**Planning application no: 2021/94552**

**Land at, Barnsley Road, Denby Dale, Huddersfield HD8 8TS.**

**Erection of 53 dwellings and associated works**

**Comments for inclusion in the public consultation relating to the above planning application.**

Appendix 1: Notes on Drainage Strategy

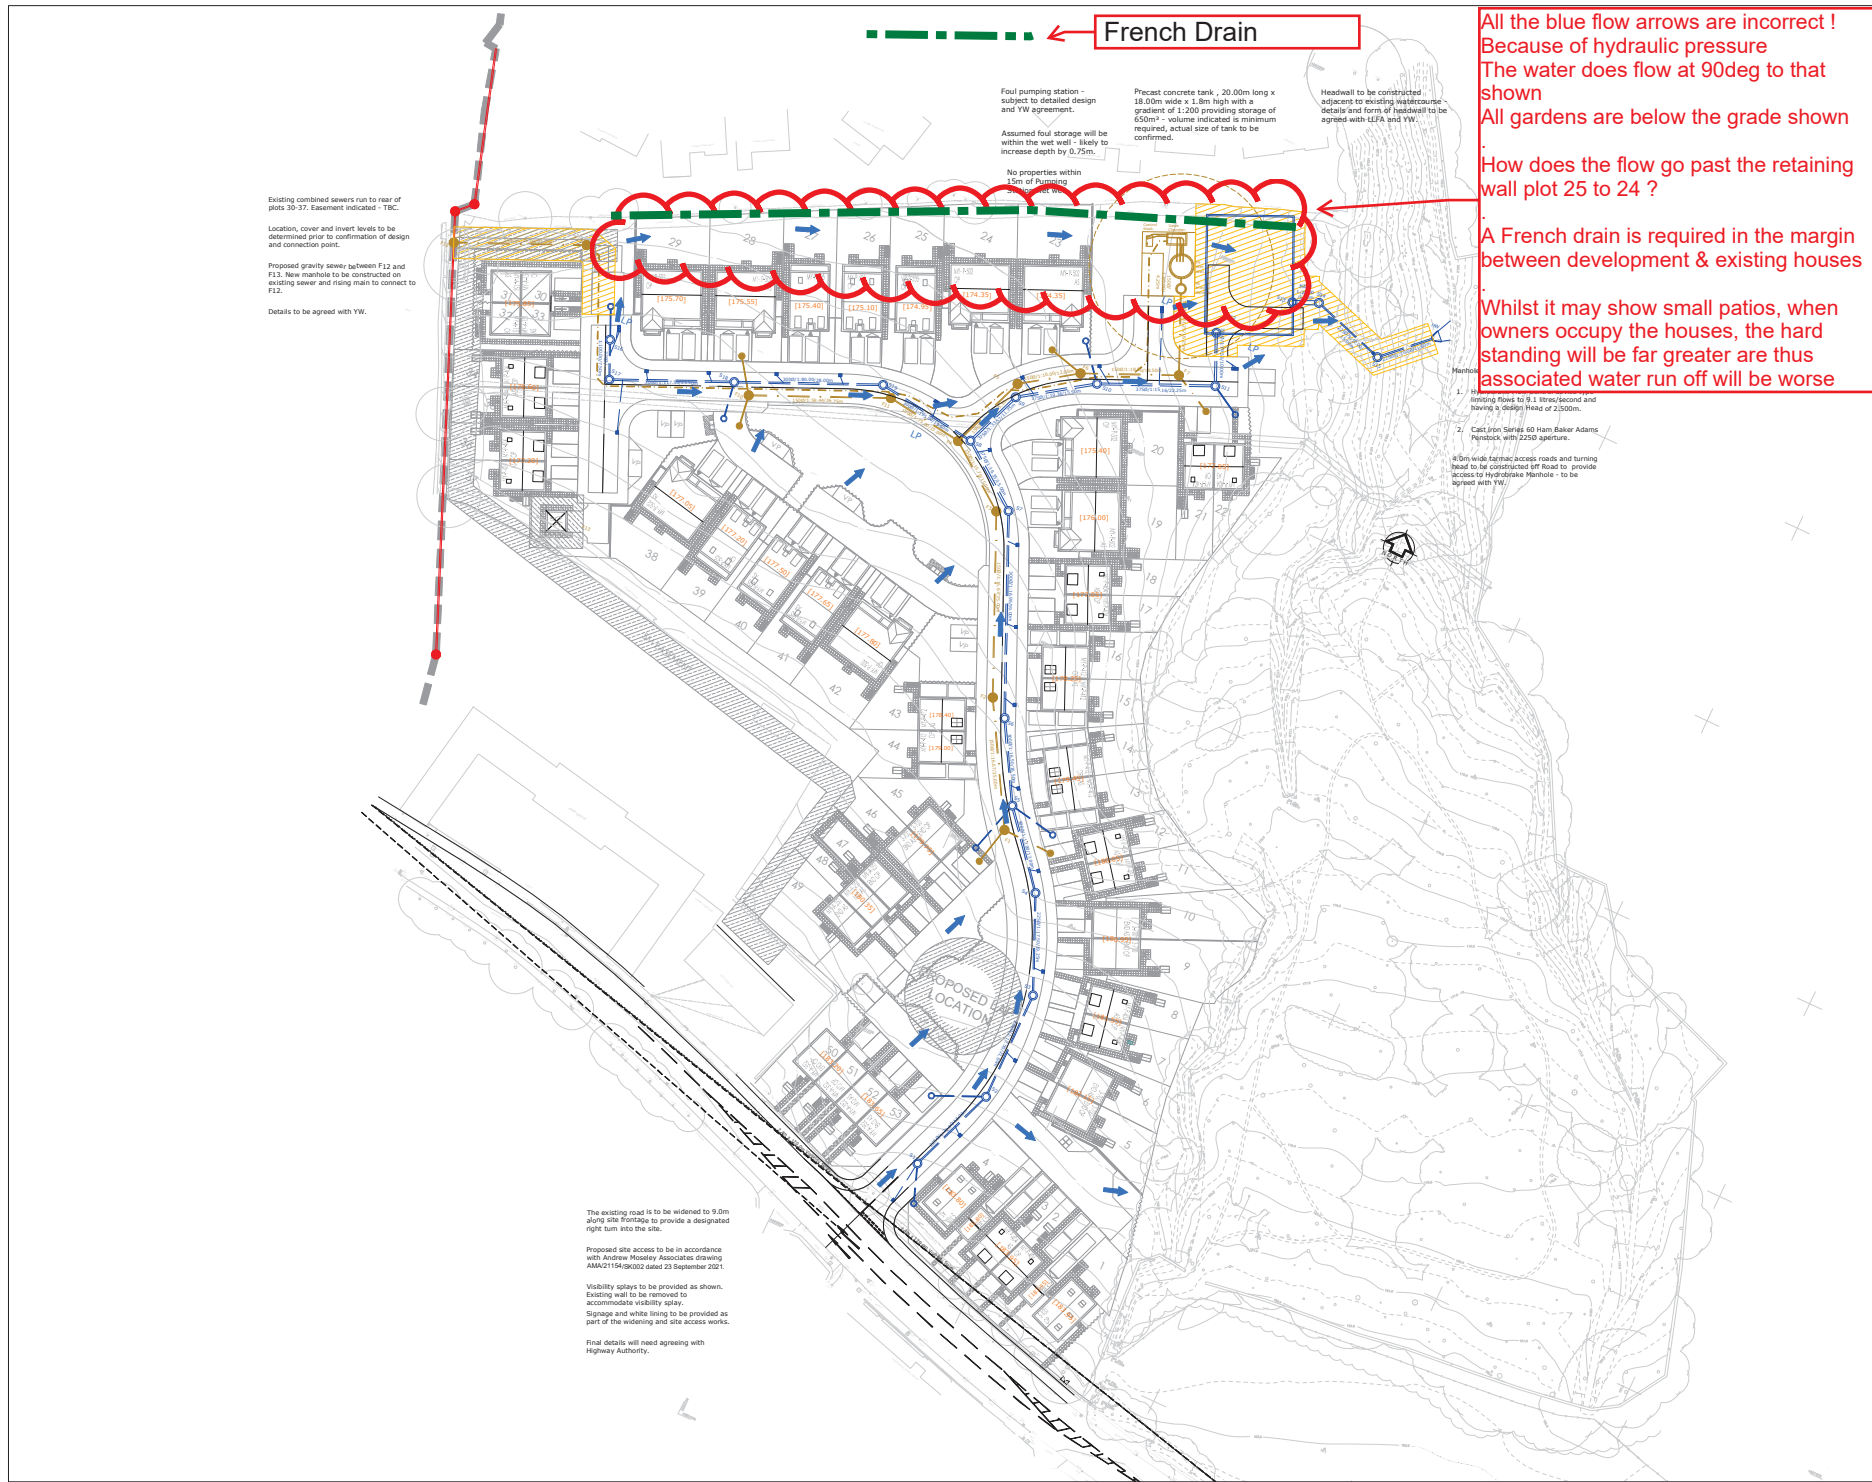
All the blue flow arrows are incorrect !  
Because of hydraulic pressure  
The water does flow at 90deg to that shown  
All gardens are below the grade shown

Whilst it may show small patios, when owners occupy the houses, the hard standing will be far greater are thus associated water run off will be worse

| Drainage Strategy Plan                                                                |             |             |          |

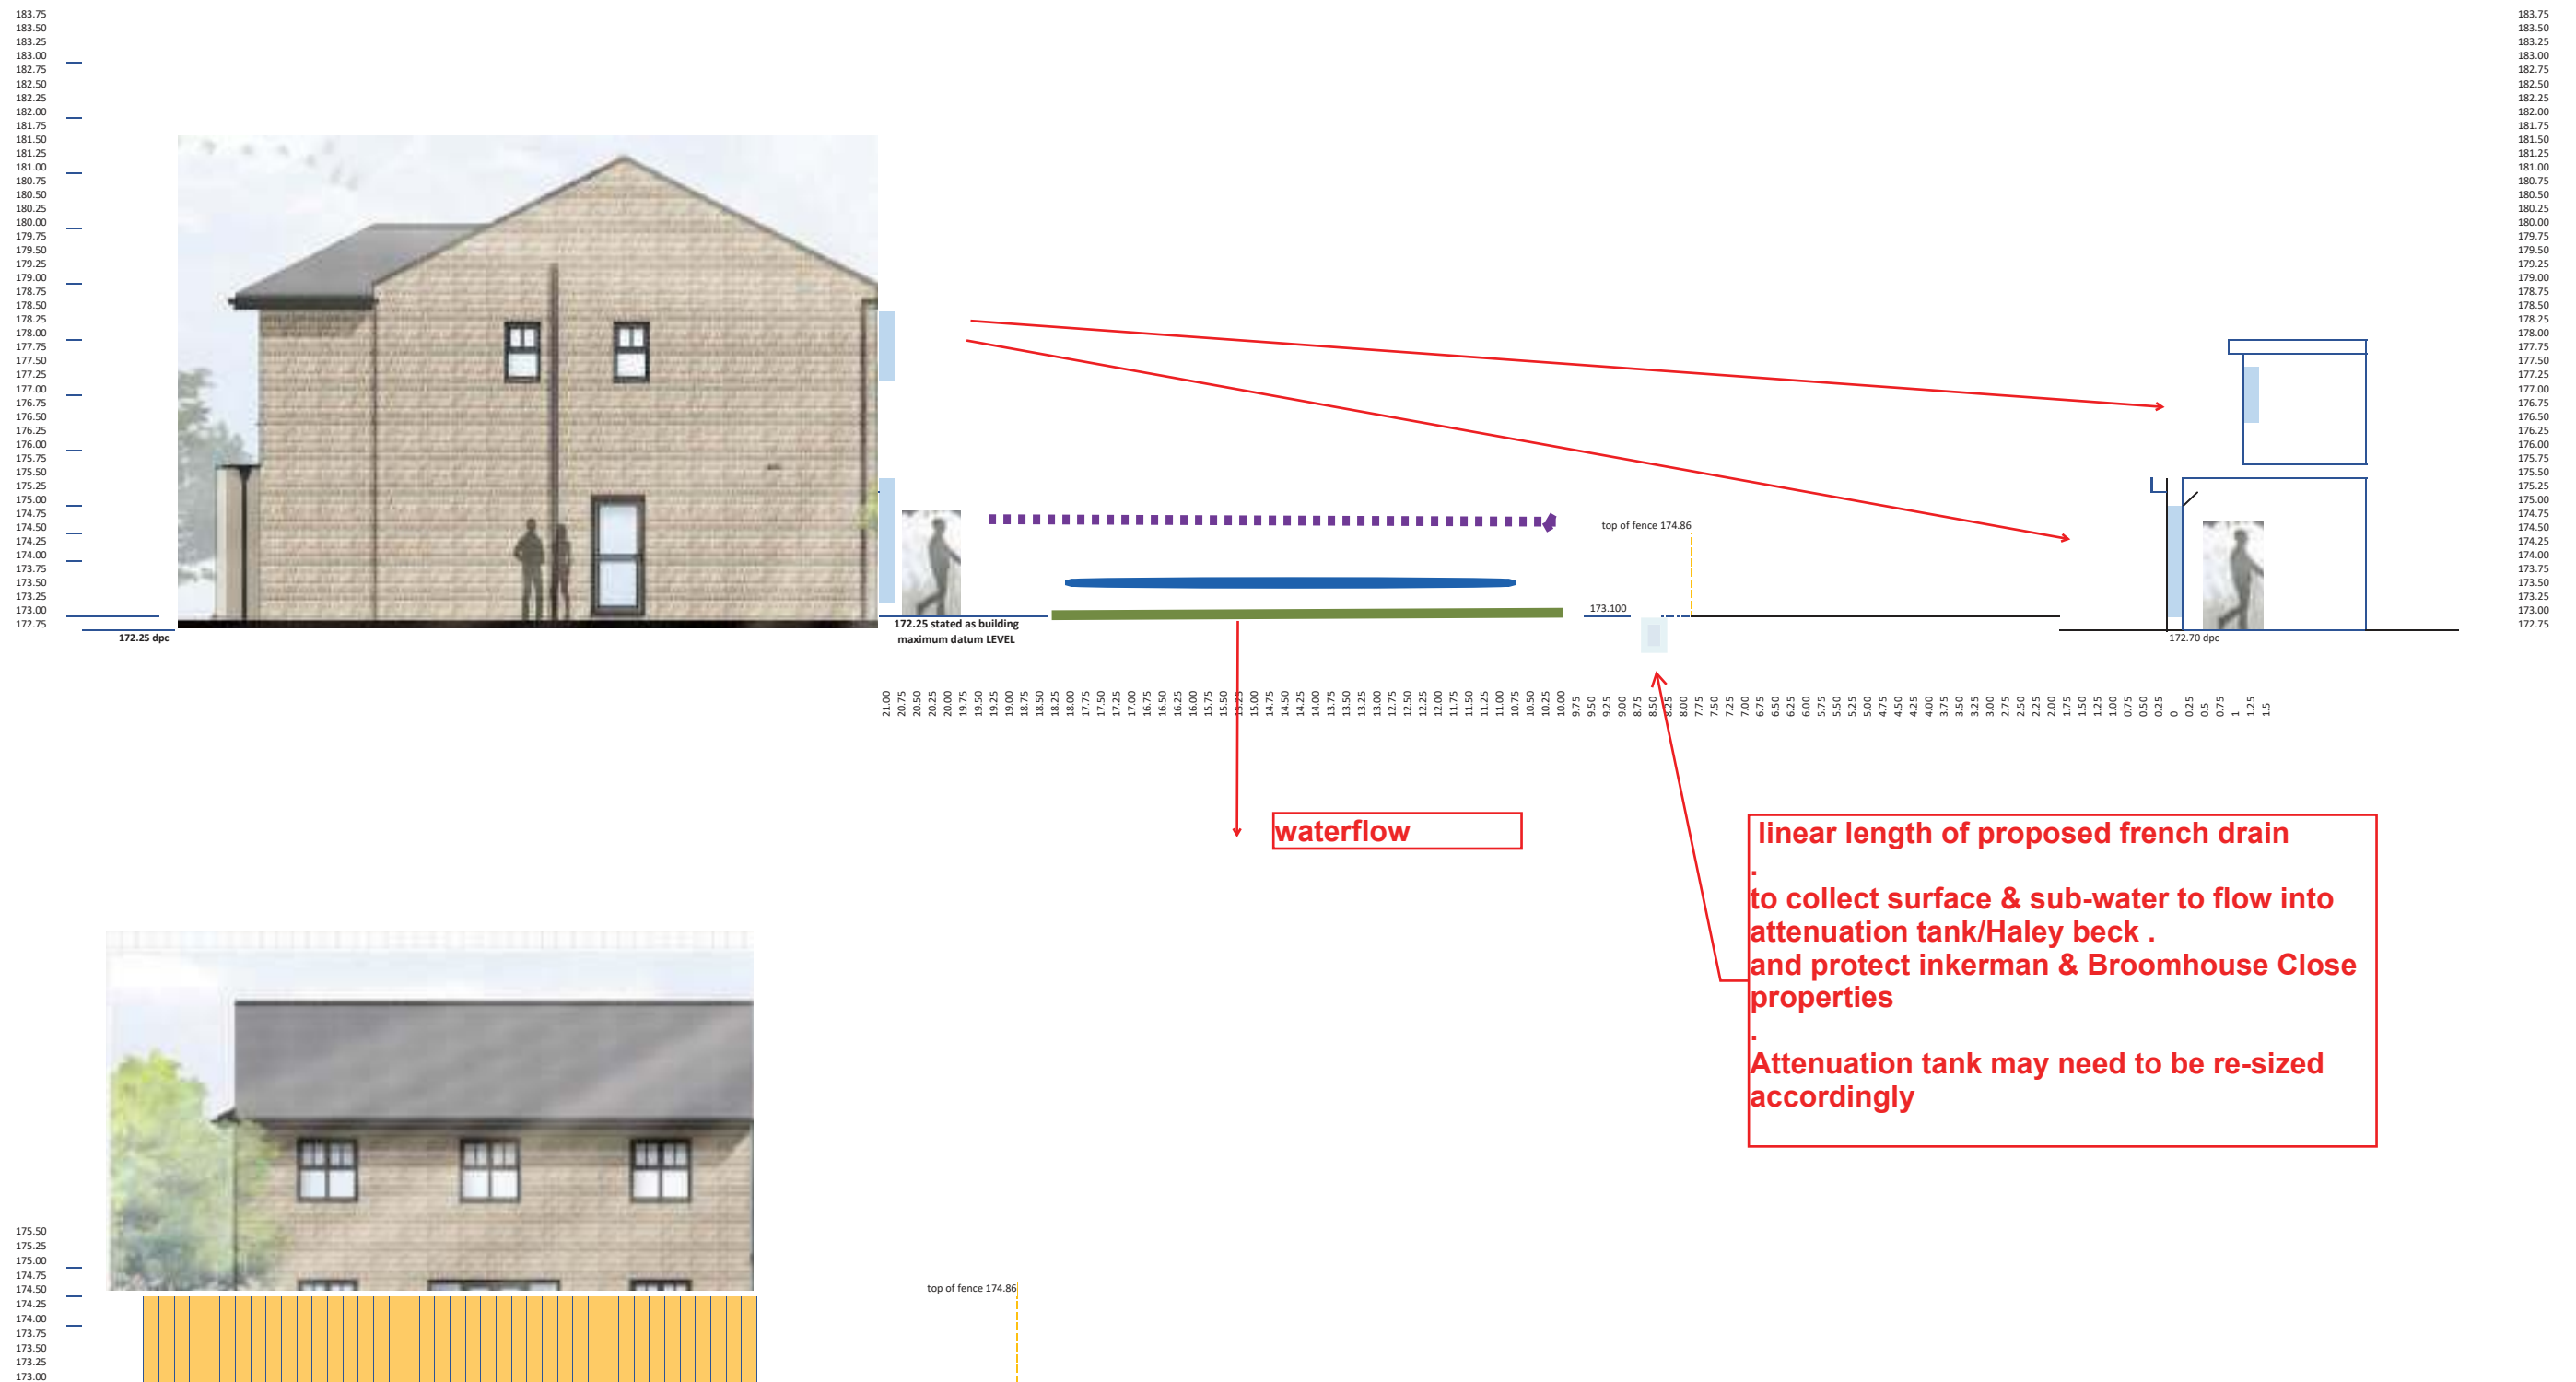
The pump sewer route is not a straight line and there is no sealed pipeline manhole access points over this convoluted length to provide access to in the event of a blockage.

how is this prevented to become additional parking area ?  
especially if access required 24hrs in case of breakdown  
Yellow hatched zone?

## BARNSELEY ROAD, DENBY DALE - CONCEPT MASTERPLAN

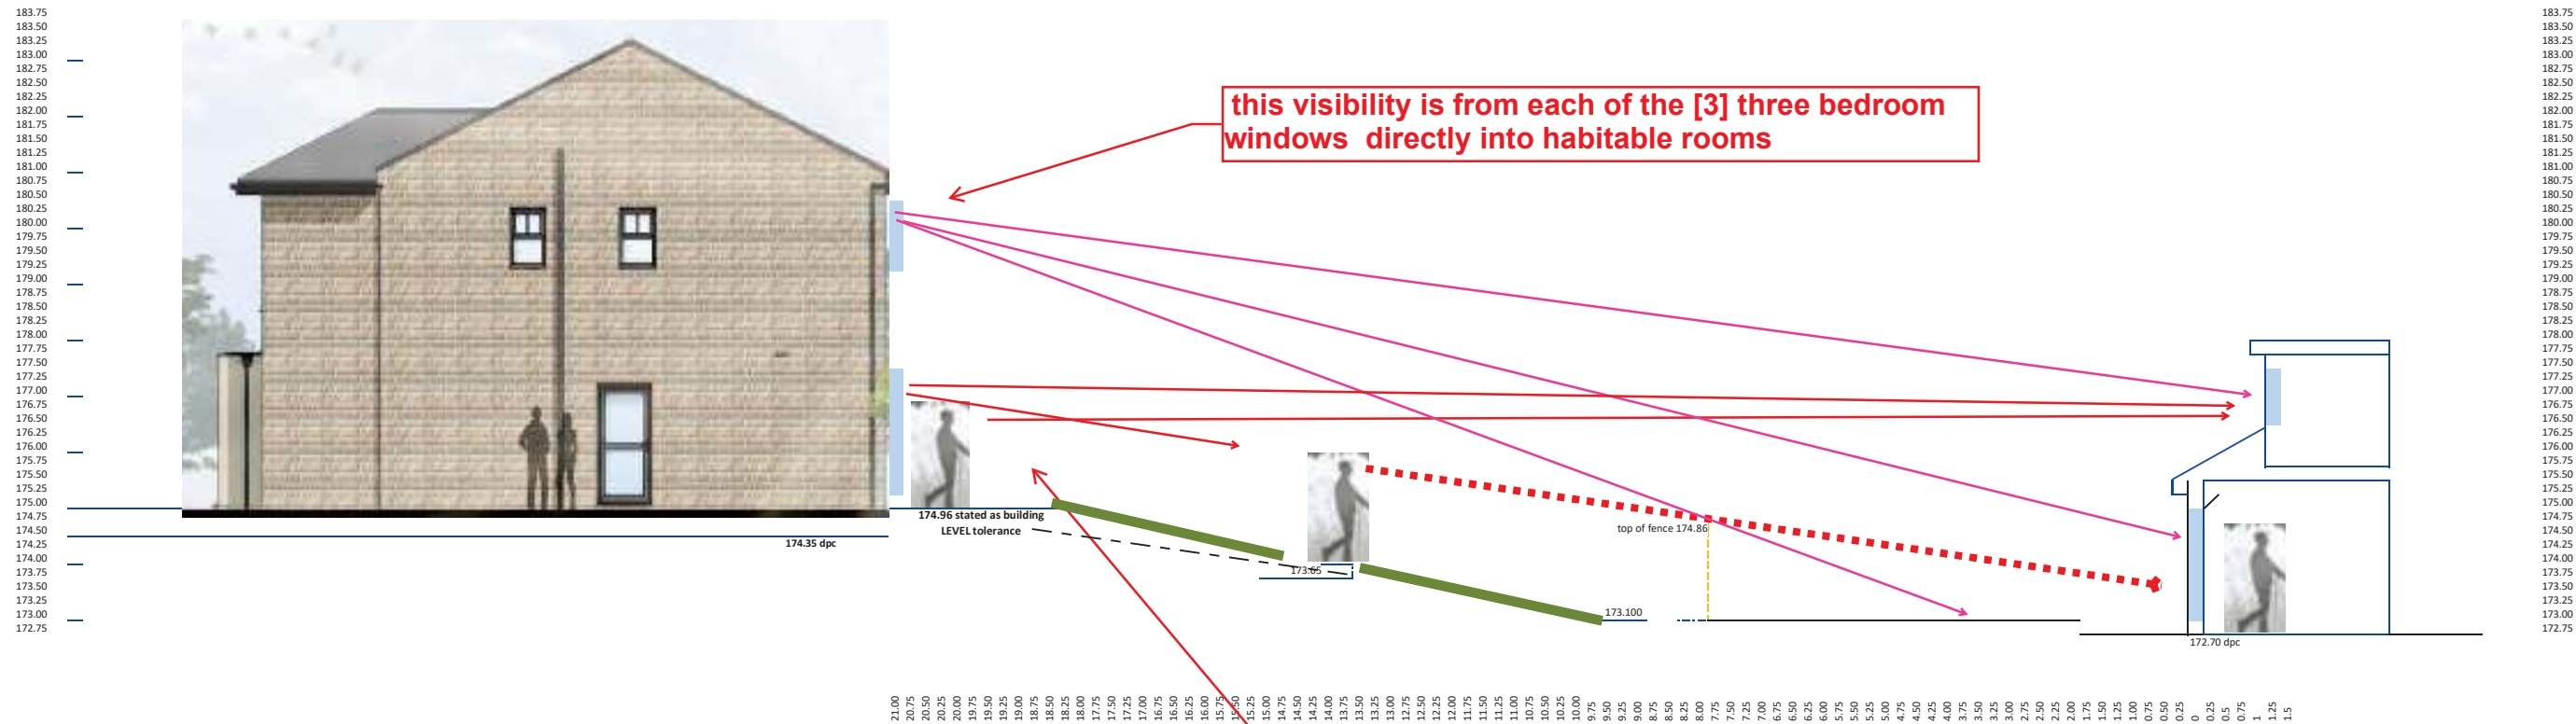
We would also ask why the balancing pond shown on the northern boundary of the original concept masterplan (see Appendix 3) has now been replaced by an attenuation tank? In the Statement of Community involvement, Pegasus Group state that this *'takes into account feedback from the Council's Officers received during the pre-application process'* but in a conversation with the Kirklees Planning Case Officer on the 9<sup>th</sup>, February 2022 he was unaware of any such feedback. A written question to establish the nature of this feedback to the Planning Office remains unanswered.
